UNITED STATES PATENT AND TRADEMARK OFFICE

10/518,712

Office Action Summary

DETAILED ACTION

Takahashi '4,895,000 Figure 1 Prior Art

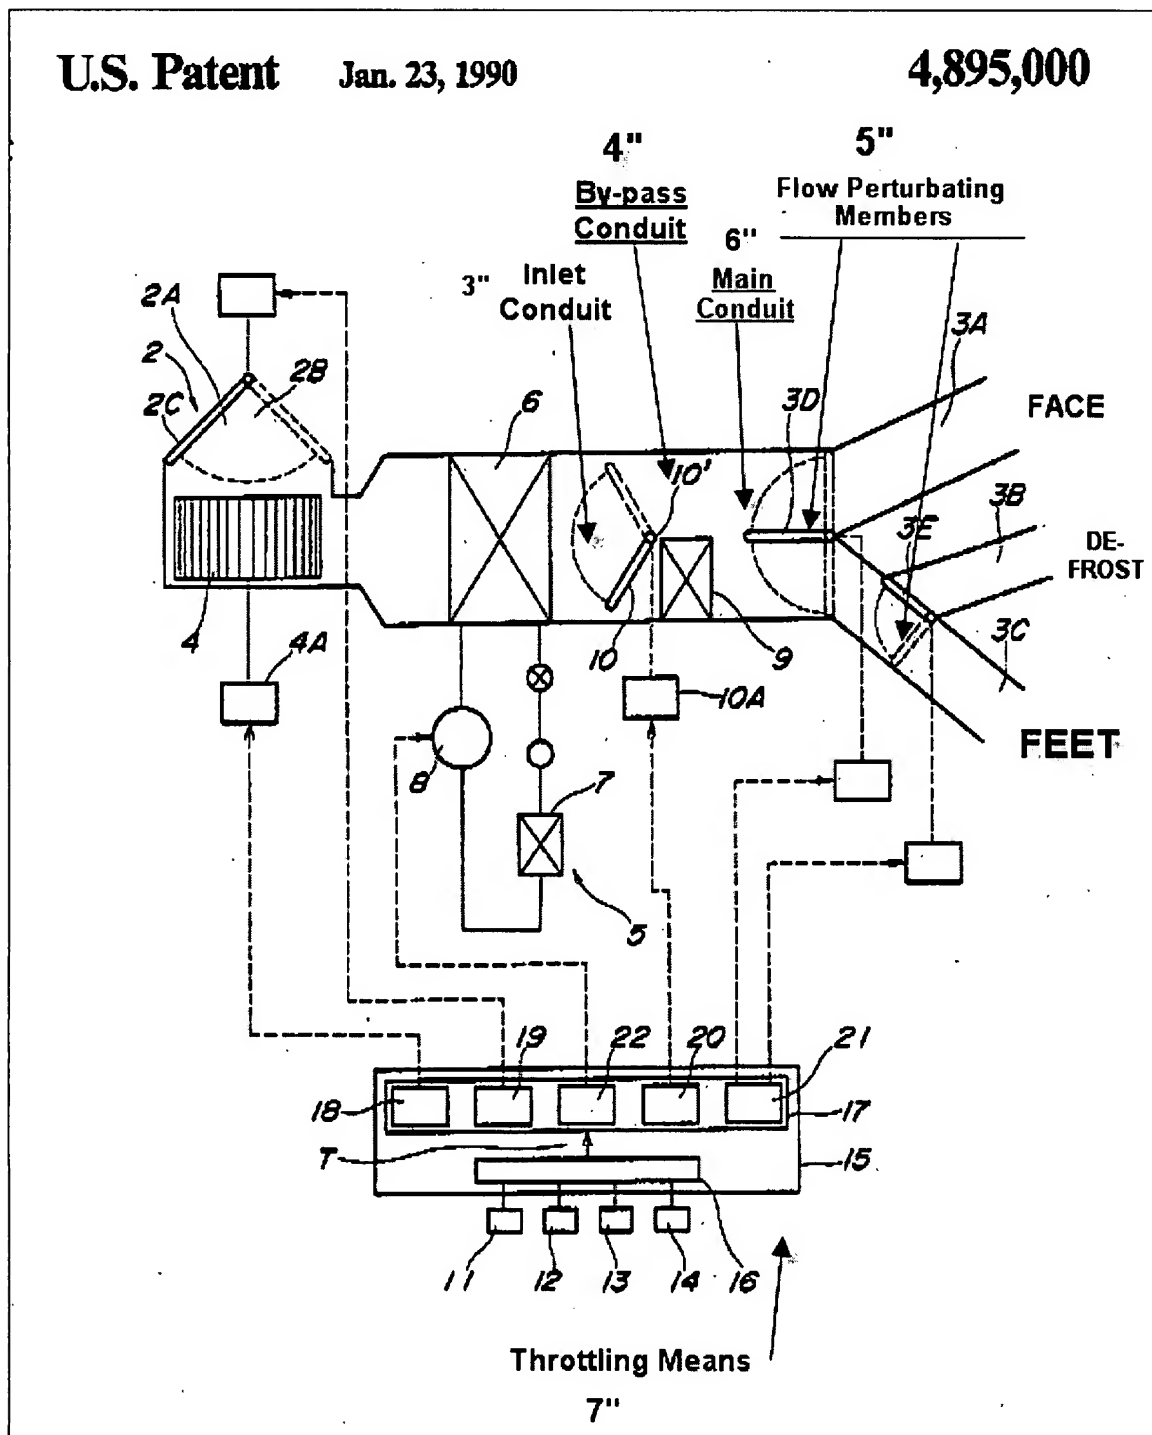
14. In re claim 1, Takahashi '000 discloses an air distributor device (figure 1) including: a structure defining a main conduit (6") and a plurality of outlet conduits (3A, 3B, 3C) communicating with the main conduit (6") and to be connected to a plurality of outlets for the outflow of air into the motor vehicle passenger compartment, Coanda effect distributor means mounted in the structure of the distributor device and movable to a plurality of operative positions each causing deviation, by the Coanda effect, of the air flowing through the main conduit (6") into a selected one of said outlet conduits (3A, 3B,

3C), characterized in that said distributor device further comprises: a radiating mass (9) positioned upstream of the main conduit (6") in such a way as to be traversed by the flow of air which arrives into the main conduit (6") from an inlet conduit (3") of the distributor device, to heat said flow of air, means which determine a variation of the temperature of the flow of air conveyed in said main conduit (6"), said means being controlled by said Coanda effect distributor means, in such a way that the temperature of the air flowing out of the distributor device is a function of the operative position (i.e. air-mixing damper (10)) of said Coanda effect distributor means. (See note 1 below)

Coanda effect distributor means in prior art is simply identified as air-conditioning unit with the **Coanda Effect** taking place within it inherently as air flows along its smooth walls. Dampers have ability to 'throw' air to opposite wall of hinged side where air continues its "gripping" flow.

15. In re claim 2, Takahashi '000 discloses said distributor device (figure 1) further comprises a by-pass conduit (4") which connects the inlet conduit (3") to the main conduit (6") in parallel to the portion of conduit where the aforesaid radiating mass (9) is positioned, and means for throttling (7") obstructing the various distributor flow of the said by-pass said by-pass operative positions of the Coanda effect means which determine the deviation of the main conduit (6") into one of the aforesaid conduit (3A, 3B, 3C) for variably conduit depending upon outlet conduits (3A, 3B, 3C), in such a way that the temperature of the flow of air exiting the distributor device has different values depending on which outlet conduit (3A, 3B, 3C) has been selected through said Coanda effect distributor means . (See note 1 above)

16. In re claim 3, Takahashi '000 discloses invention above, and further discloses said Coanda effect distributor means comprise at least a flow perturbing member (5") having at least two different operative positions to cause the deviation, by Coanda effect, of the flow of air that travels through the main conduit (6") at least into a first (3A)

or into a second (3B, 3C) outlet conduit, and in that said throttling means (7") are constituted by a shutter (10) mechanically connected to said flow perturbing member (5"). (See note 1 above)

17. In re claim 8, Takahashi '000 discloses the distributor device further comprises a mixing controlling shutter (10) which controls an opening which places the inlet conduit (3") in communication directly with the main conduit (6"), in parallel with respect to the conduit portion in which the radiating mass (9) is positioned.

18. In re claim 10, Takahashi '000 discloses invention above and further discloses three outlet conduits (3A, 3B, 3C) respectively to be connected to outlets which direct the air adjacent to the floor of the motor vehicle passenger compartment, to outlets situated in the front part of the dashboard of the motor vehicle oriented towards the occupants of the motor vehicle, and to outlets situated at the base of the windshield of the motor vehicle, and in that the aforesaid throttling means (7") are shaped and positioned in such a way as to generate in the main conduit (6") a flow having a first, relatively lower, temperature, when the Coanda effect distributor means deviate the flow of air into the outlet conduit (3A) communicating with the front outlets (FACE), a flow of air at a second, relatively higher temperature when the Coanda effect distributor means send the flow of air from the main conduit (6") to the outlet conduit (3C) connected to the outlets adjacent to the floor of the motor vehicle (FEET) passenger compartment, and a flow of air having a third, still higher temperature, when the Coanda effect distributor means deviate the flow of air from the main conduit (3) to the third outlet conduit (3B) communicating with the outlets situated at the base of the windshield of the motor vehicle (DEFROST). See note 2 below.

Heating core (3) is disposed directly in front of conduit which feeds front outlets (FACE) and windshield (DEFROST) outlets and with the proper opening angles of dampers (shutters) claim limitation regarding varying temperature across the three outlets (3A,

3B, 3C) can be achieved, especially being that the warmest temperatures are from the face and windshield outlets.

19. In re claim 11, Takahashi '000 discloses invention above and further discloses it is provided with means for regulating the heating or cooling air including a mixing controlling shutter (10) which controls an opening that places the inlet conduit (3") of the distributor device directly in communication with the main conduit (6") in parallel to the portion of conduit in which the radiating mass (9) is positioned, characterised in that said mixing controlling shutter (10) is operatively connected to said Coanda effect distributor means, in such a way that to different operative positions of the Coanda effect distributors also correspond different operative positions of the mixing controlling shutter (10). See notes 1 and 2 above.

Kawai et al '6,138,749 Figure 2

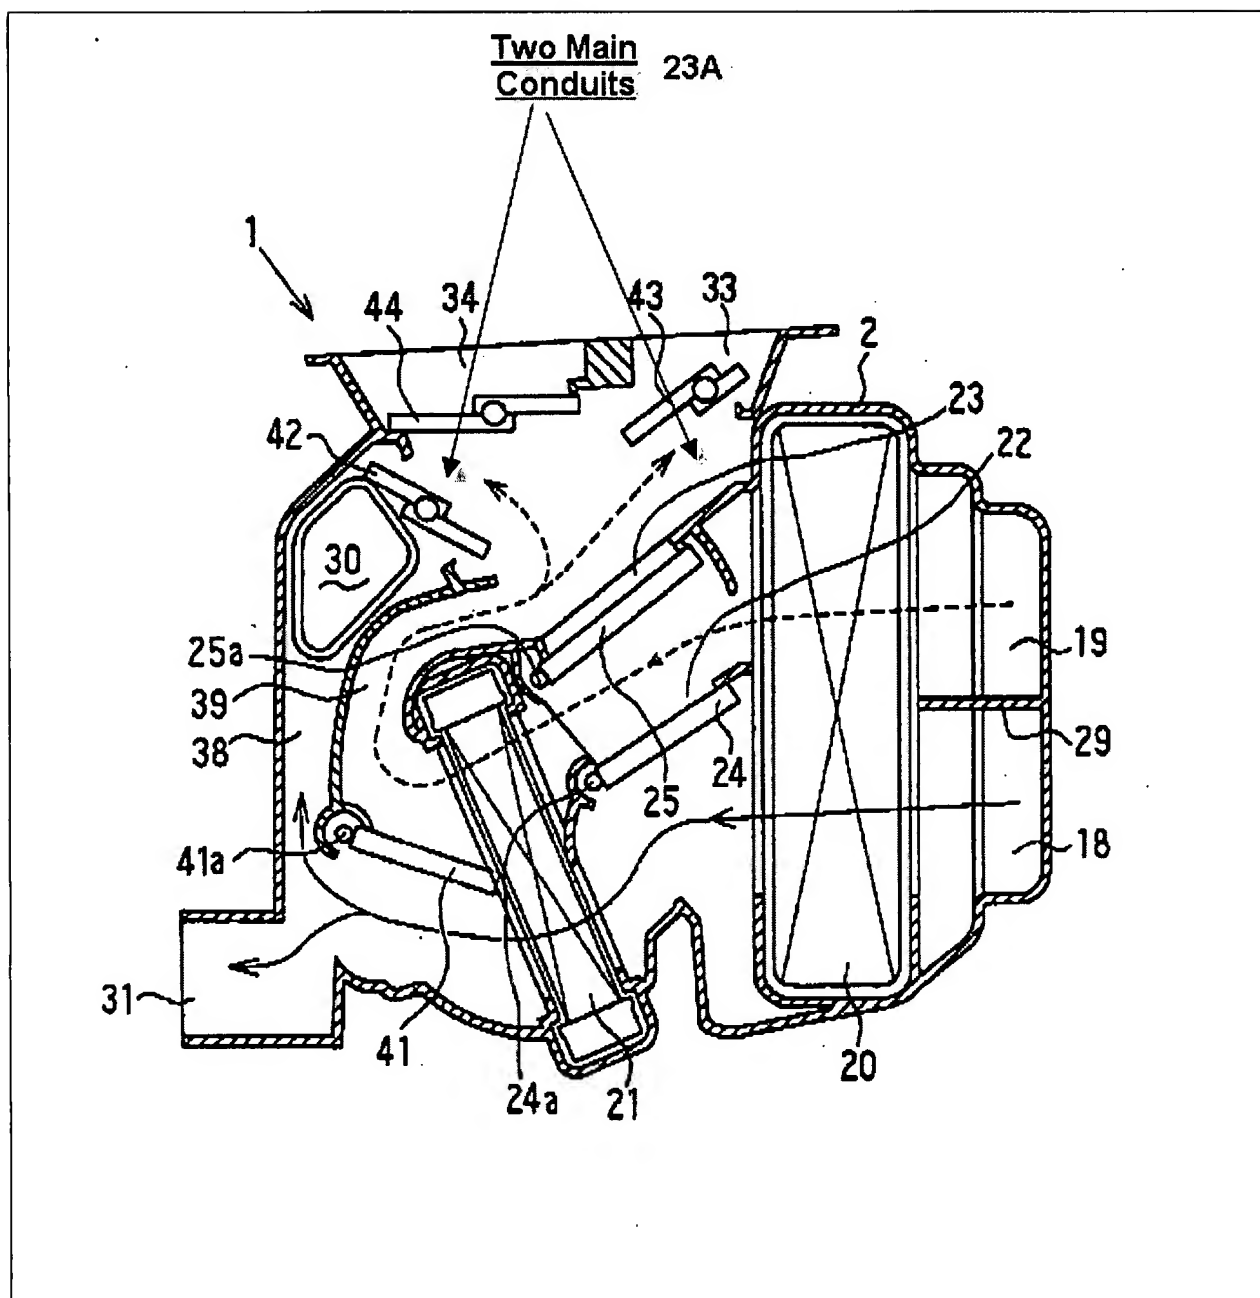
21. In re claim 1, Kawai et al '6,138,749 discloses an air distributor device (figure 2) including: a structure defining a main conduit (23A) and a plurality of outlet conduits (30, 33, 34) communicating with the main conduit (23A) and to be connected to a plurality of outlets for the outflow of air into the motor vehicle passenger compartment, Coanda effect distributor means mounted in the structure of the distributor device and movable to a plurality of operative positions each causing deviation, by the Coanda effect, of the

air flowing through the main conduit (23A) into a selected one of said outlet conduits (30, 33, 34), characterized in that said distributor device further comprises: a radiating mass (21) positioned upstream of the main conduit (23A) in such a way as to be traversed by the flow of air which arrives into the main conduit (23A) from an inlet conduit (18, 19) of the distributor device, to heat said flow of air, means which determine a variation of the temperature of the flow of air conveyed in said main conduit (23A), said means being controlled by said Coanda effect distributor means, in such a way that the temperature of the air flowing out of the distributor device is a function of the operative position (i.e. air-mixing damper (24, 25)) of said Coanda effect distributor means. (See note 1 above)

24. In re claim 9, Kawai et al '749 discloses invention above and further discloses an air distributor and mixer assembly comprising a plurality of main conduits (23A) set

mutually side by side and each communicating with a plurality of outlet conduits (30, 33, 34), each main conduit (23A) being provided with respective Coanda effect distributor means, with a respective by-pass conduit (22, 23) and with respective throttling means (24, 25). As best understood applicant is claiming two or more air distribution devices in unison. Kawai et al '749 does contain some redundancies reading into claim language, however does not claim to be a plurality of devices. Furthermore, patentable weight for the duplication of parts is not granted per MPEP citation below. Submission of amended drawing set and concise description of embodiment in specification will resolve all issues regarding claim structure.

25. It would have been obvious to one of ordinary skill in the art at the time of the invention was made to modify Kawai et al '749 singular device with plurality of devices to increase the heating output of device where application required such.

Kawai et al '6,138,749 Figure 5

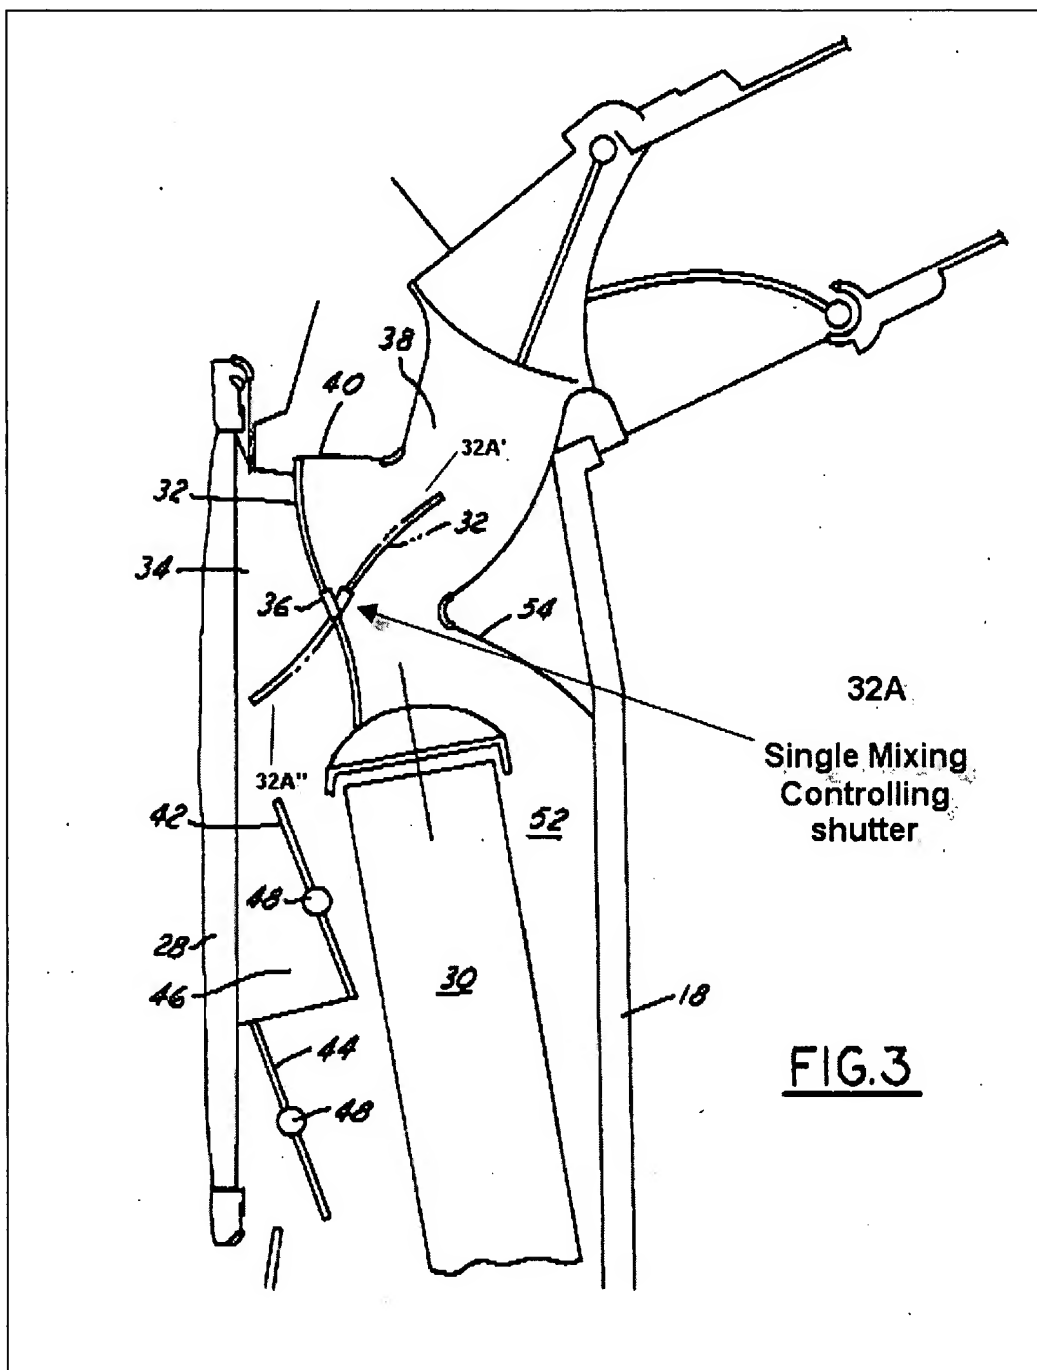
26. In re claim 13, Kawai et al '749 discloses invention above and further discloses at least two main conduits (23A) set mutually side by side, communicating with respective sets of outlet conduits (30, 33, 34, figure 2) which in turn are connected to a series of outlets situated in the central (32, 35, 36, figure 5) part of the dashboard of the motor vehicle and to a series of outlets situated on a side (37, figure 5) of the dashboard of the motor vehicle.

27. However, Kawai et al '749 fails to disclose that to the two aforesaid main conduits is associated a single mixing controlling shutter comprising two portions, angularly offset from each other and positioned in a single chamber for feeding air to the two main conduits, in such a way as to favor a greater flow of cold air towards the main conduit communicating with the central outlets than towards the main conduit communicating with the lateral outlets.
